Project Title and Location: **Exterior Window and Door Replacement
160-430 Boullee St., London
Contract No. LON00016400-BS**

ADDENDUM NO. 2

TITLE
Window & Door Opening Details

TITLE
Schedules & Wall Section Details

W9 QTY: 34

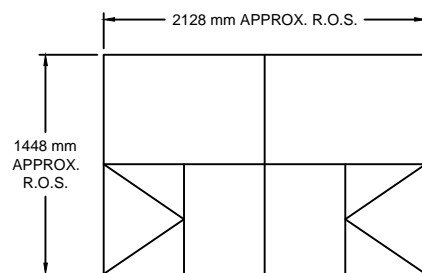
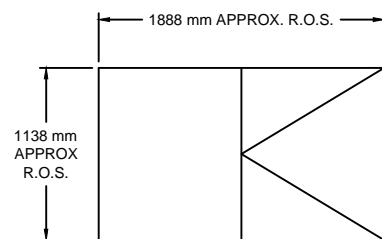
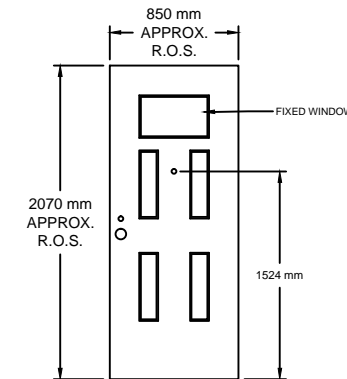
- A revised window schedule has been included with this addendum outlining the updated window quantities and layouts (no single hung windows are included and W9 has been changed to a Slider-Fixed-Slider configuration).

1 BASEMENT WINDOW HEAD DEMOLITION

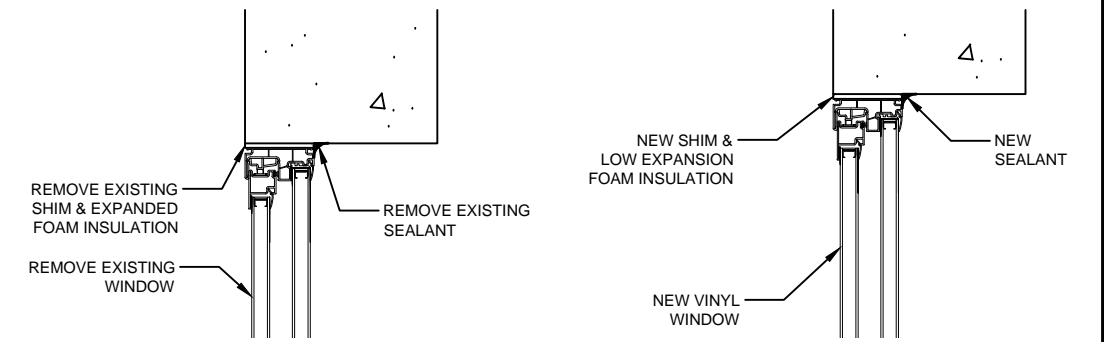
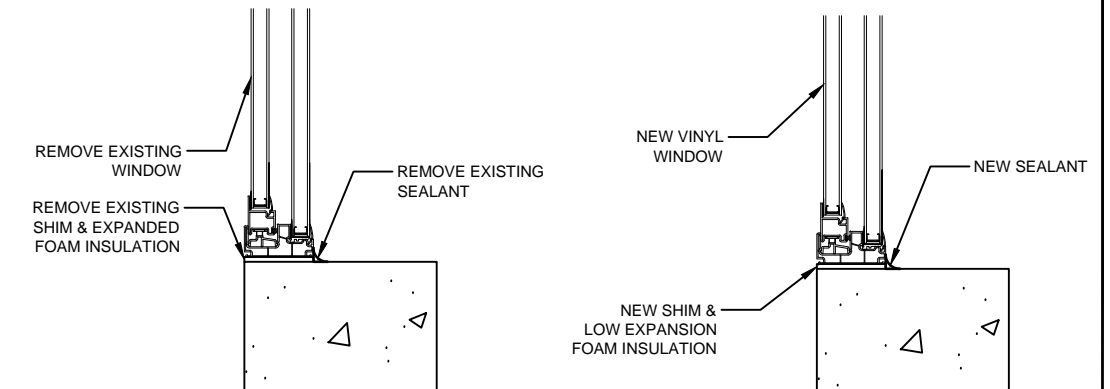
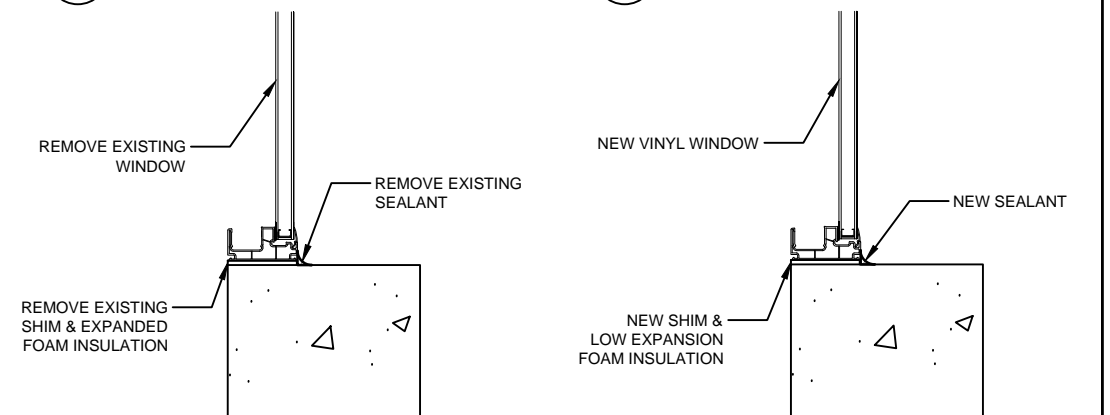
- A revised Bid Form and Summary of Work are attached to allow a separate price for the replacement of the basement windows (W6). LMHC will include the replacement of these windows at their discretion.
